# 1988 - 1989 Corvette: Recall: Evaporative Emission Hoses

**Subject:** CAMPAIGN: EVAPORATIVE EMISSION HOSES

**Model and Year:** 1988-89 CHEVROLET CORVETTE

**Bulletin Number:** 89C25 - (08/23/1993)

FIGURE 1

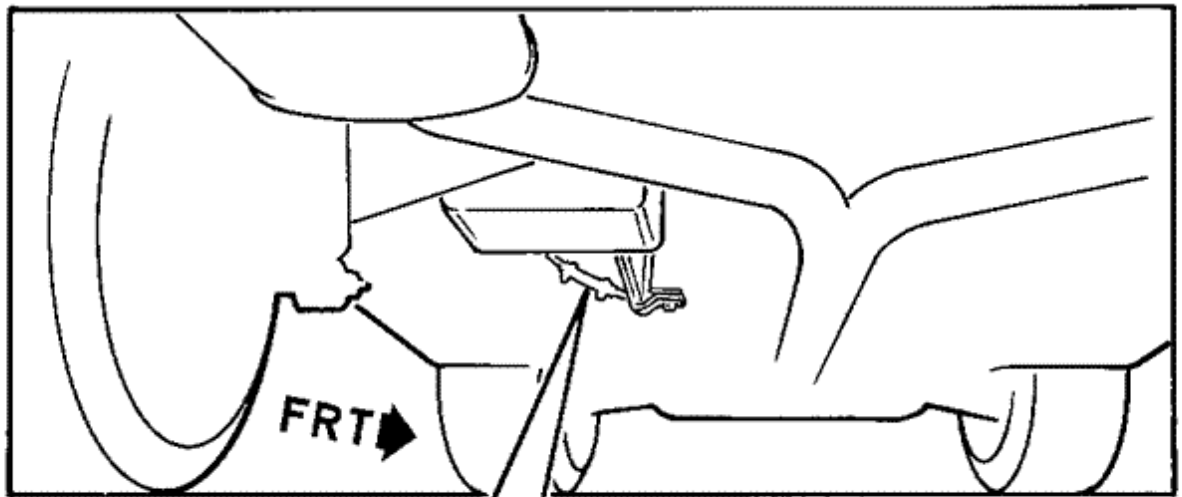
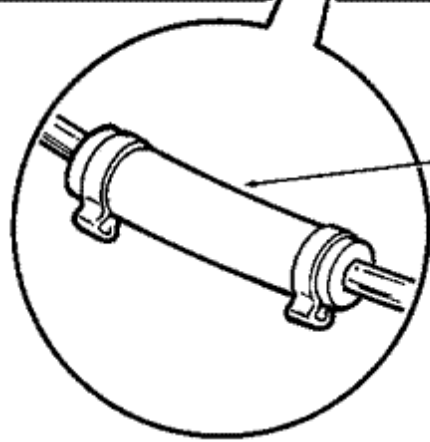
General Motors has determined that certain 1988-89 Chevrolet Corvette model vehicles may experience a condition in which two (2) suspect evaporative emission hoses may deteriorate, crack and leak.

1. Raise vehicle.
2. Referring to Figure 1, locate rubber hose (approximately 2-9/16" long - 65mm) connecting fuel tank evaporative emission pipe to chassis fore-aft evaporative emission pipe.

3. Remove both hose clamps and hose. Hose clamps and hose will not be reused.
4. Inspect pipes and bend if required to insure ends of pipes are in line with one another.

5. Install two (2) new clamps (P/N 01622744) and new hose (P/N 09442928) onto pipe ends. Insuring hose is positioned an equal distance over both ends. Position clamps onto hose and secure.

HOSE MUST BE POSITIONED  
EQUALLY OVER BOTH PIPES

FIGURE 2

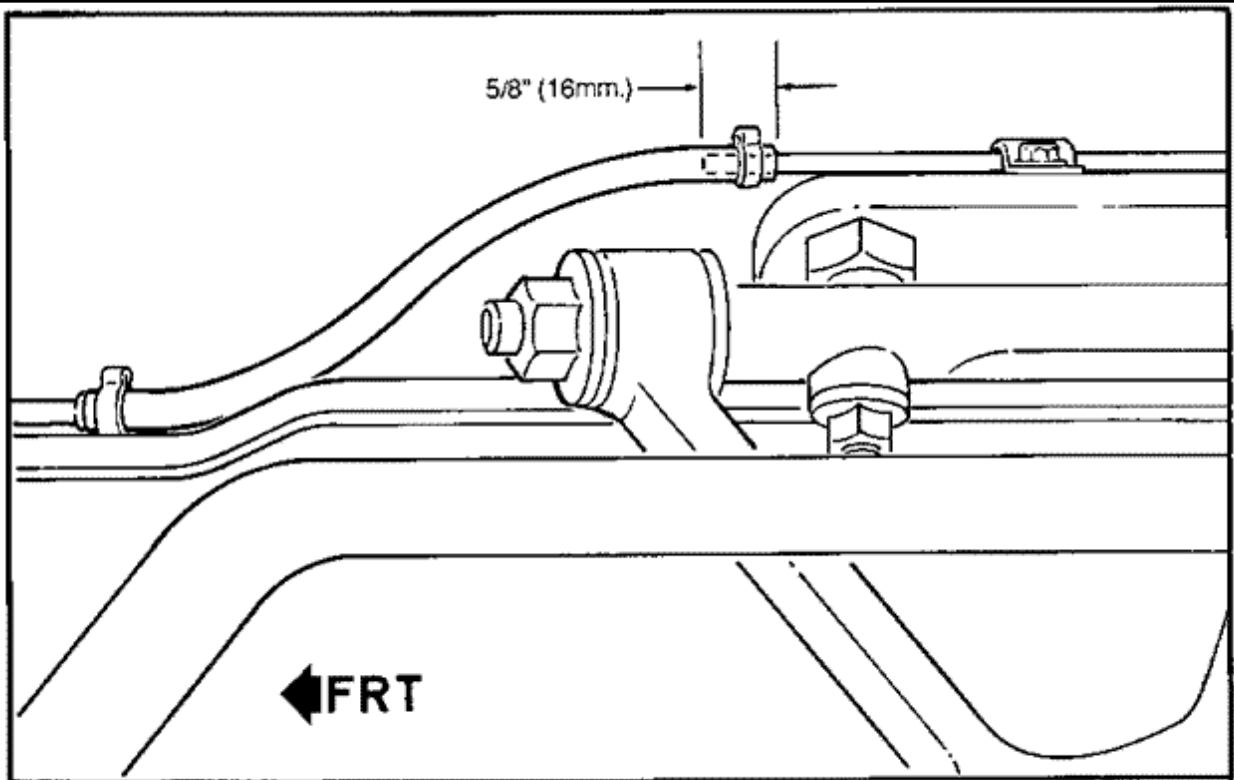
6. Lower vehicle.
7. Underhood, locate the evaporative emission hose connecting chassis fore/aft evaporative emission pipe to evaporative emission line shown in Figure 2.

8. Remove both hose clamps and hose. Hose clamps and hose will not be reused.
9. Install new large clamp (P/N 10028454) over nylon evaporative emission line, and install new small clamp (P/N 01622744) over chassis pipe.

10. Install larger end of new hose (P/N 10248651) over nylon evaporative emission line and install the opposite end approximately 1/2" over the fore/aft chassis pipe as illustrated in Figure 2.

**Notice: If hose appears taut when assembled as indicated above, repositioning of chassis fore/aft pipe may be required to alleviate condition.**

11. Position clamps onto hose and secure.
12. Install Campaign Identification Label.
